MODEL 40X - SERIAL NO. 706
Complaint from Ziniuk & Co.

Re: Capt. Benjamin Naiman, Petah-Tiqva, Israel

FIG. 1

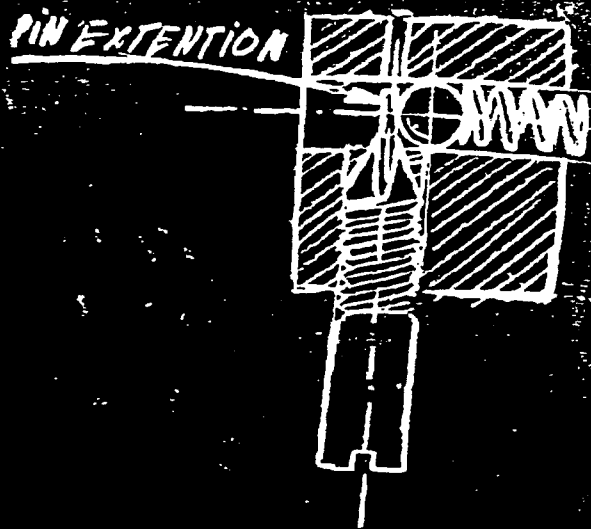
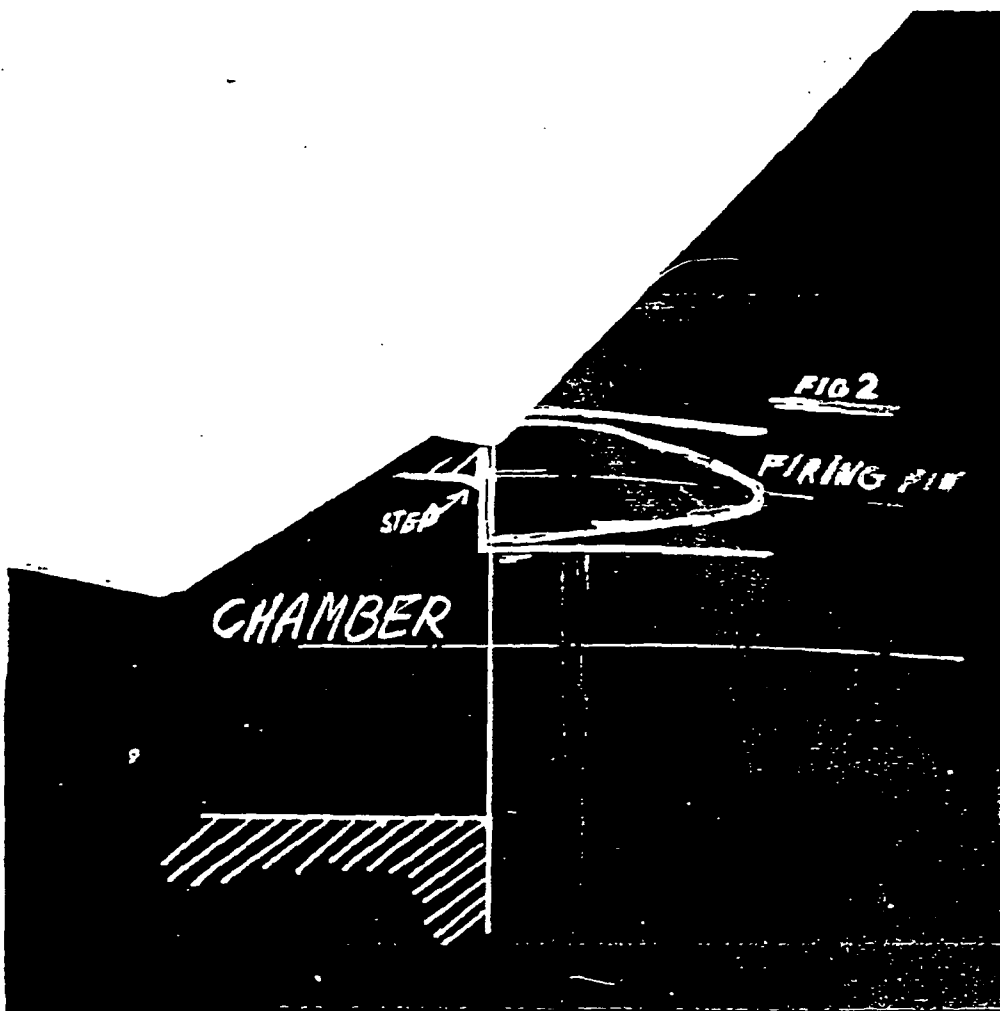
3. Interference Between Receiver & Locking Lug (Fig. 1)

We became aware of this situation incidental to production of first run of rifles and upon investigation it was found that apparently this cut in the receiver was being run with a tool having a radius which was too great and resulted in an interference with the lugs at assembly. In order to compensate for this condition a change was made to open up the diameter of the cut and the radius, which eliminated the interference at assembly.
